DOCUMENT CHANGE REQUEST

DCR number 442 Changes required for: General

Title: Transistors Low Power PNP, based on types 2N2894 and 2N2894A

Number: 5202/004

1.6.1 Metal Can Package (TO-18) - 3 lead

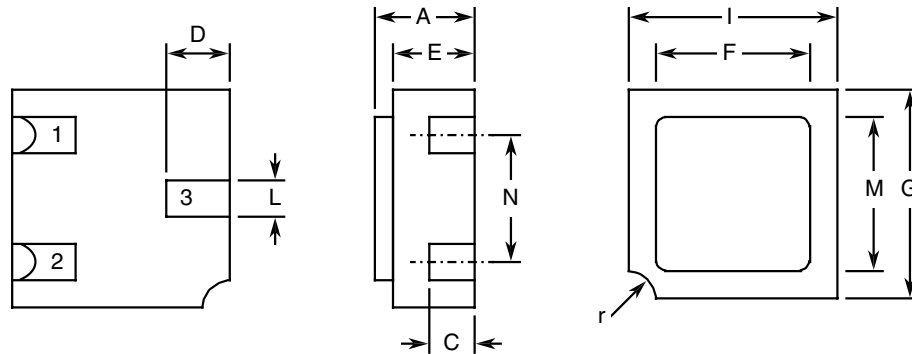
1. Rewording and restructuring of various sections and paragraphs of the specification, plus other editorial changes based on the layout and editorial content of other Detail Specifications already converted to ESCC format.
2. Deletion of redundant paragraphs and information such as Mechanical Requirements.
3. Para. 1.7 High Temperature Test Precautions requirements moved to be a note to the Maximum Ratings table.
4. Maximum Ratings table: Notes 2 and 1 interchanged.
5. Figure 1 Parameter Derating Information moved to be a note to the maximum Ratings table ("Note 1" amended).
6. Para. 4.3.2 Weight requirements moved to Component Type Variants table.
7. Figure 2 re-named "Physical Dimensions and Terminal Identification" and amended to reflect the TO-18 and CCP packages currently supplied.

1.7 FUNCTIONAL DIAGRAM

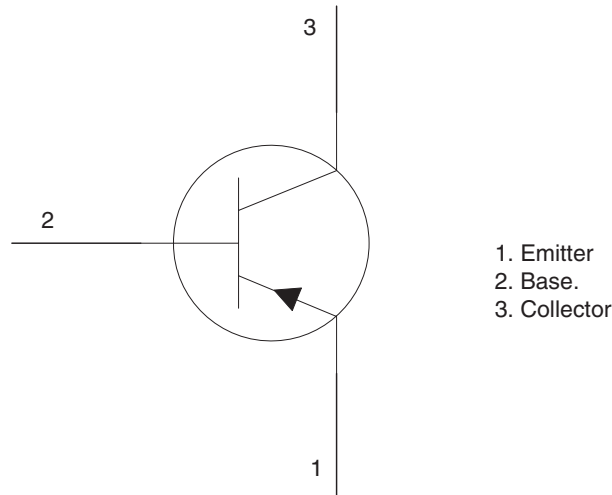
8. Figure 3, Functional Diagram: A note applicable to the Chip Carrier Package (Note 2) has been added.
9. Para. 4.4.1 Case requirements for Variants 01 to 05 corrected to reflect a TO-18 metal can.

1. For TO-18, the collector is internally connected to the case.
2. For CCP, the lid is not connected to any terminal.

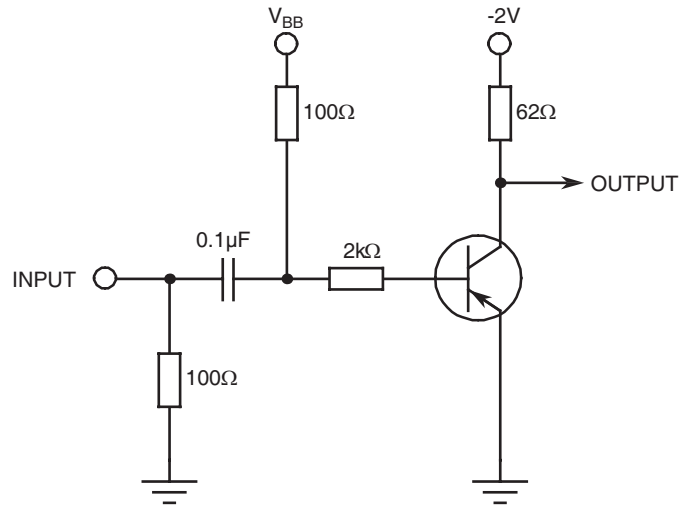
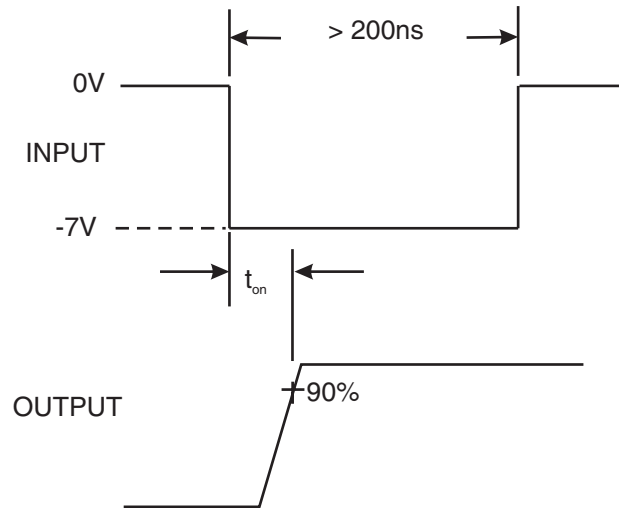
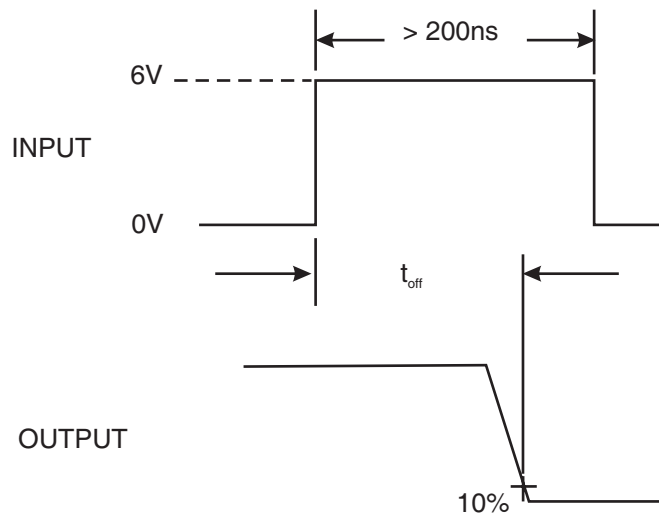
19. Table 2: Figure 4 deleted and incorporated in to a Note to Table 2 (Note 3).
20. Table 2: Replace LTPD7 sampling for AC parameters tests (designated by "Note 2") with an equivalent fixed sample of 32 components with 0 failures (or 100%).

1. Pulse measurement: Pulse Width $\leq 300\mu s$, Duty Cycle $\leq 2\%$
2. For AC characteristics read and record measurements shall be performed on a sample of 32 components with 0 failures allowed. Alternatively a 100% inspection may be performed.
3. t_{on} shall be measured using the following test circuit. The input waveform shall be supplied by a pulse generator with the following characteristics: $Z_{OUT} = 50\Omega$, $t_r \leq 2ns$, Pulse Width = $200 \pm 10ns$, Duty Cycle $\leq 2\%$. The output waveform shall be monitored on an oscilloscope with the following
